ADDENDUM NO.02

DATE: 10/12/21

'Matilda Torres High School, Toros Stadium'
Matilda Torres High School
16645 Road 26. Madera, CA 93638

DARDEN PROJECT NO. 0622.4
DSA File Nos. 10-C3
DSA APPL. NO. 02-118396

Onsite Laydown + Storage Areas

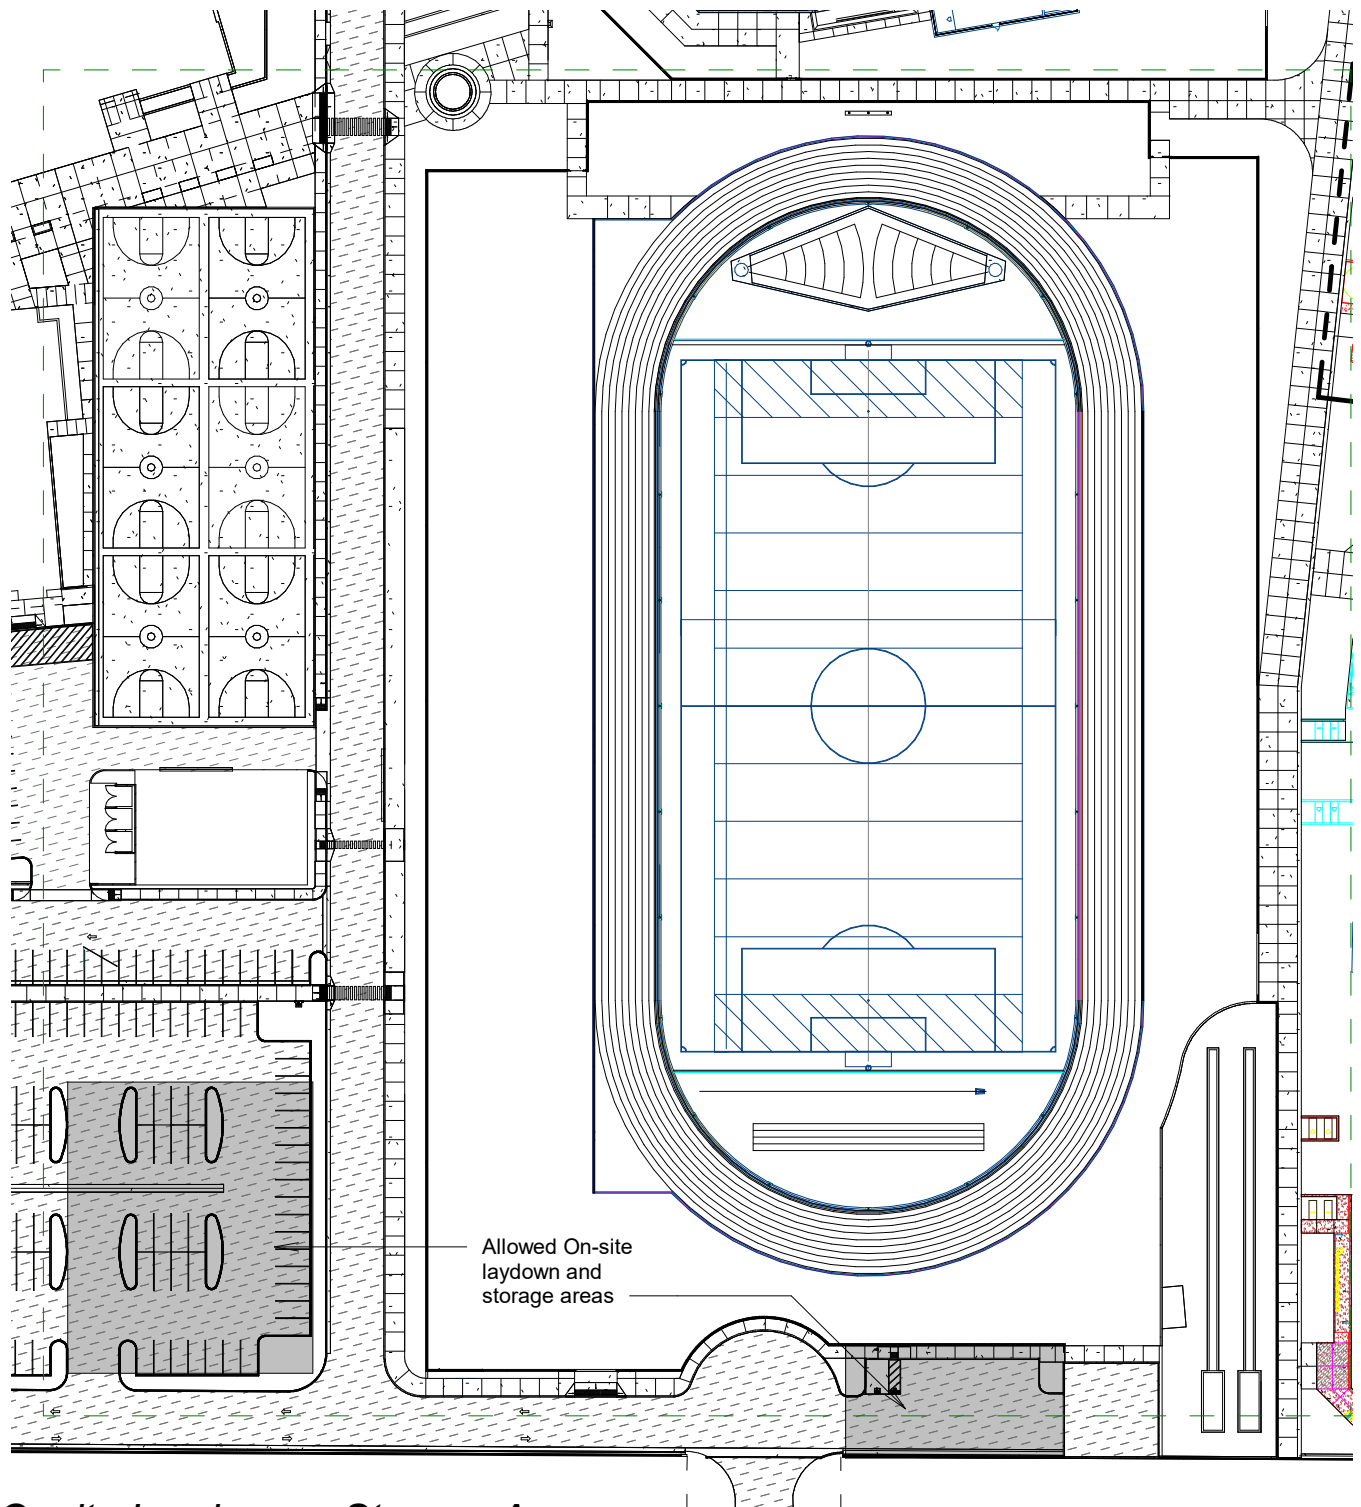
1. See Section 1.6, Paragraph E, Item 2. Add the following language
"See Attached exhibit for identified lay-down and site materials storage areas for this project."
2. Insert Attached lay-down area exhibit to end of specification section.

AD2-AX02

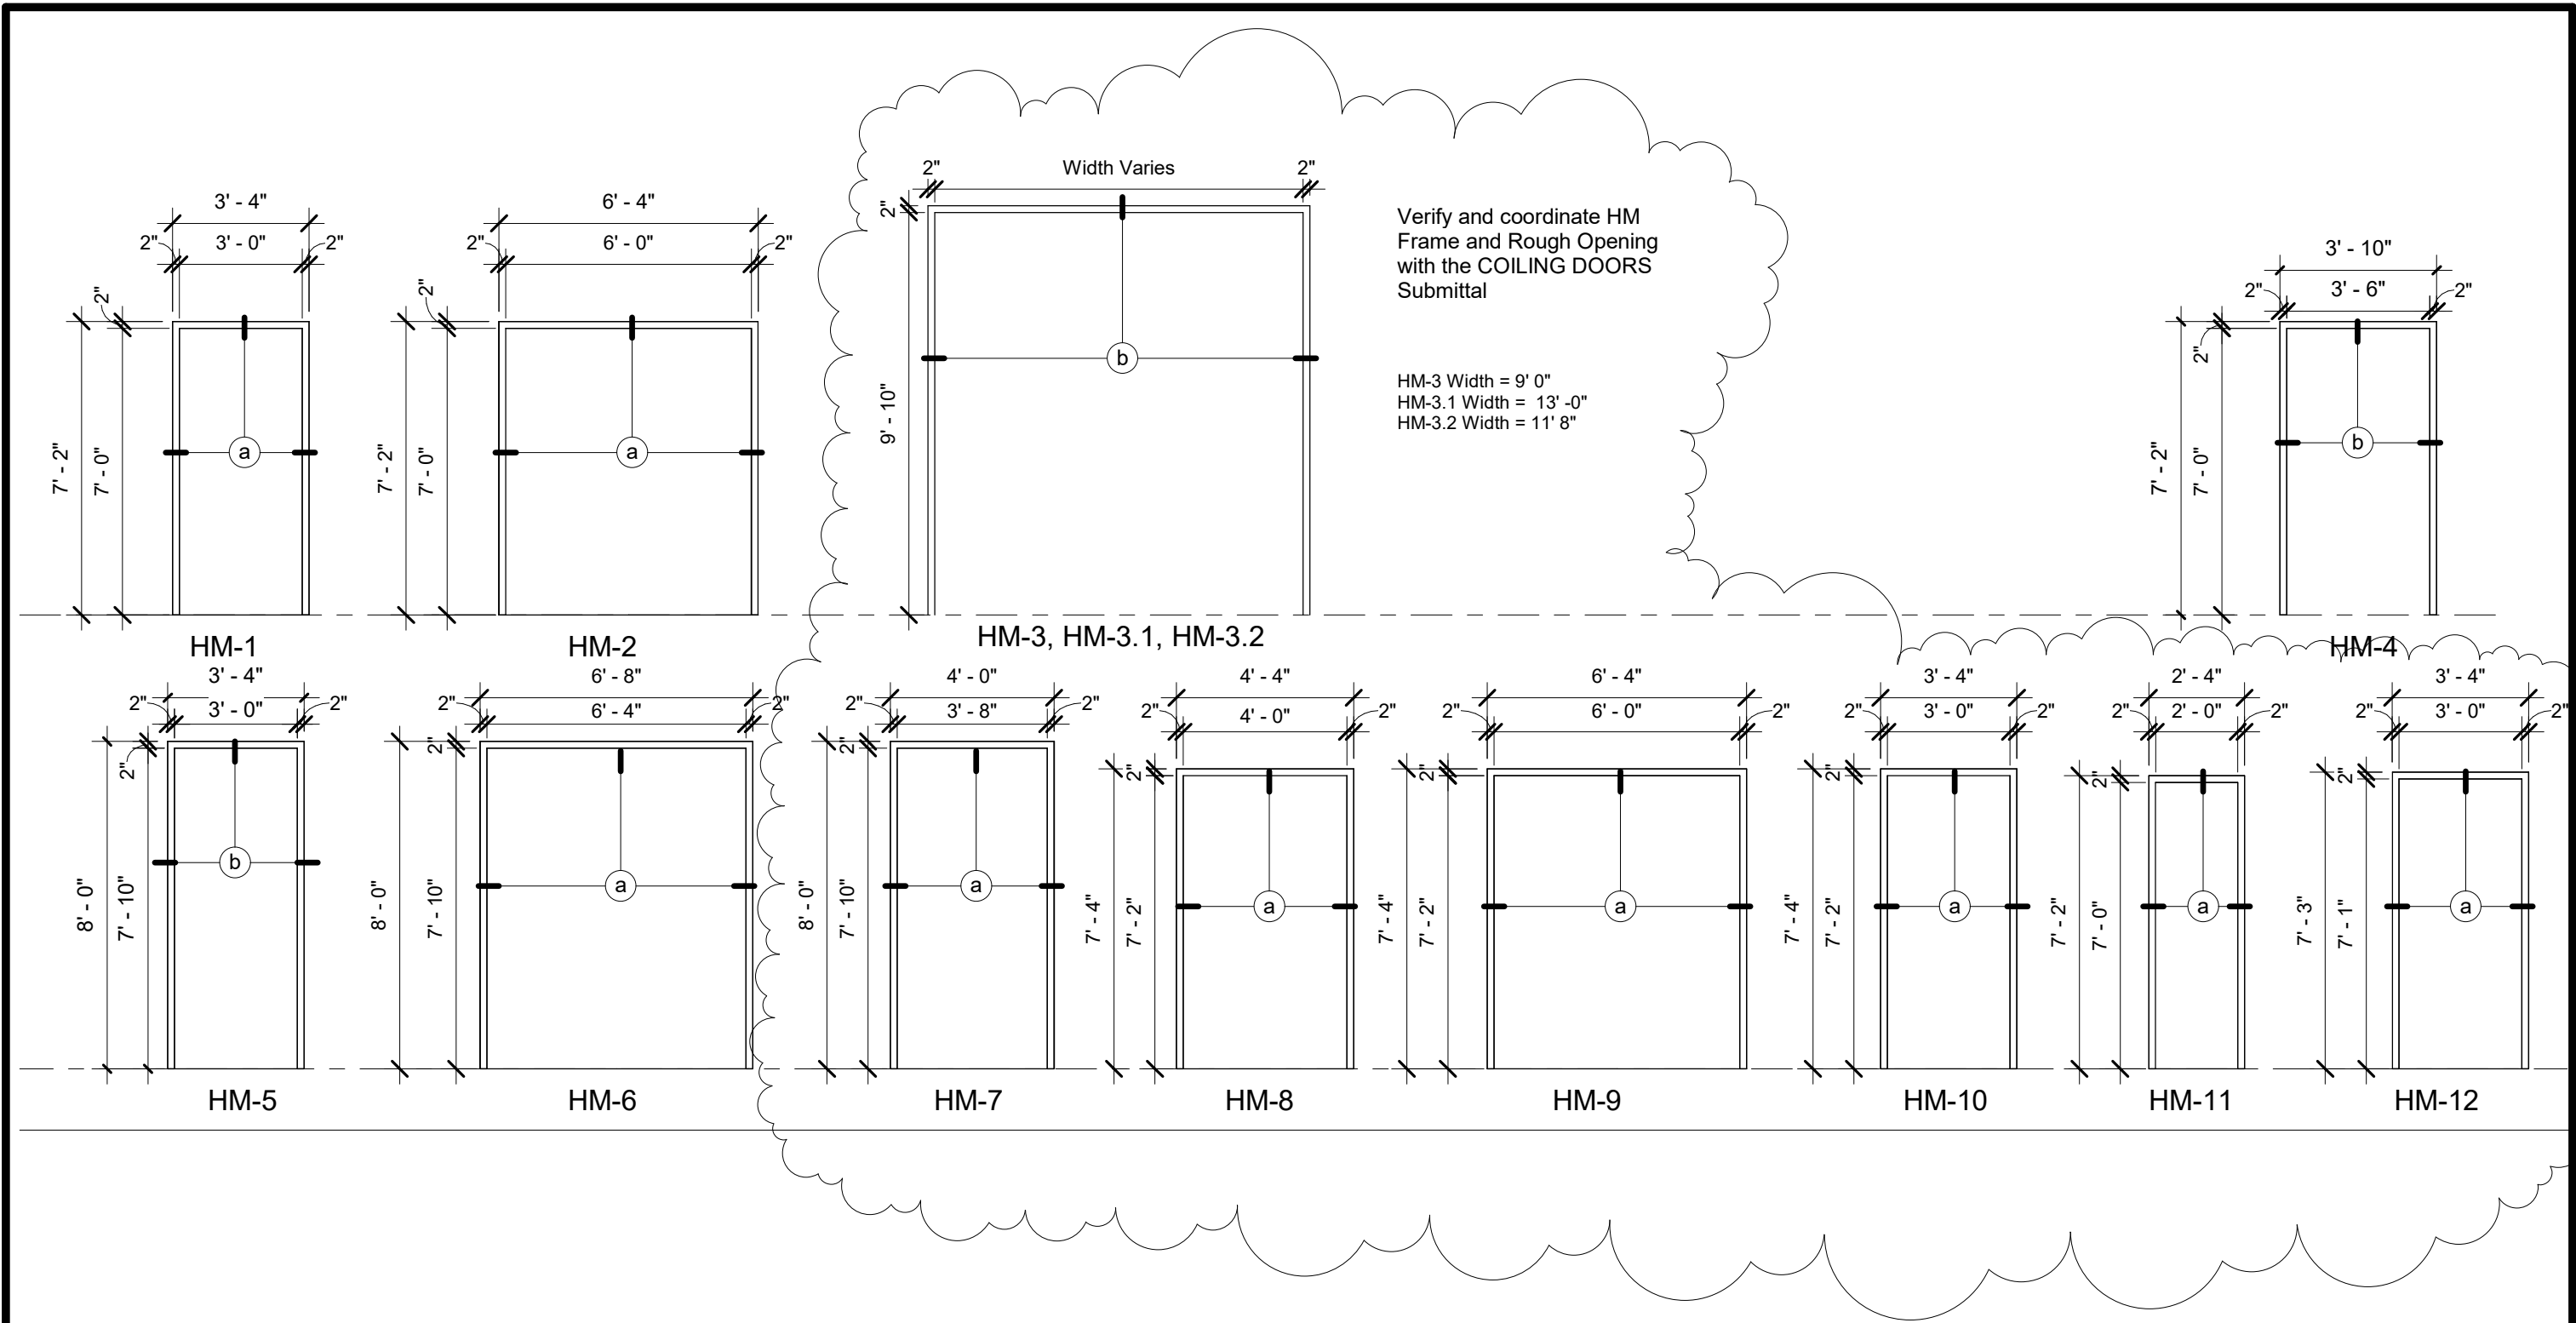
1. Replace Detail E10 – FRAME TYPES with attached drawing AD2-AX02

1. Frame types HM-3.1, HM-3.2, HM-7 thru HM-12 added
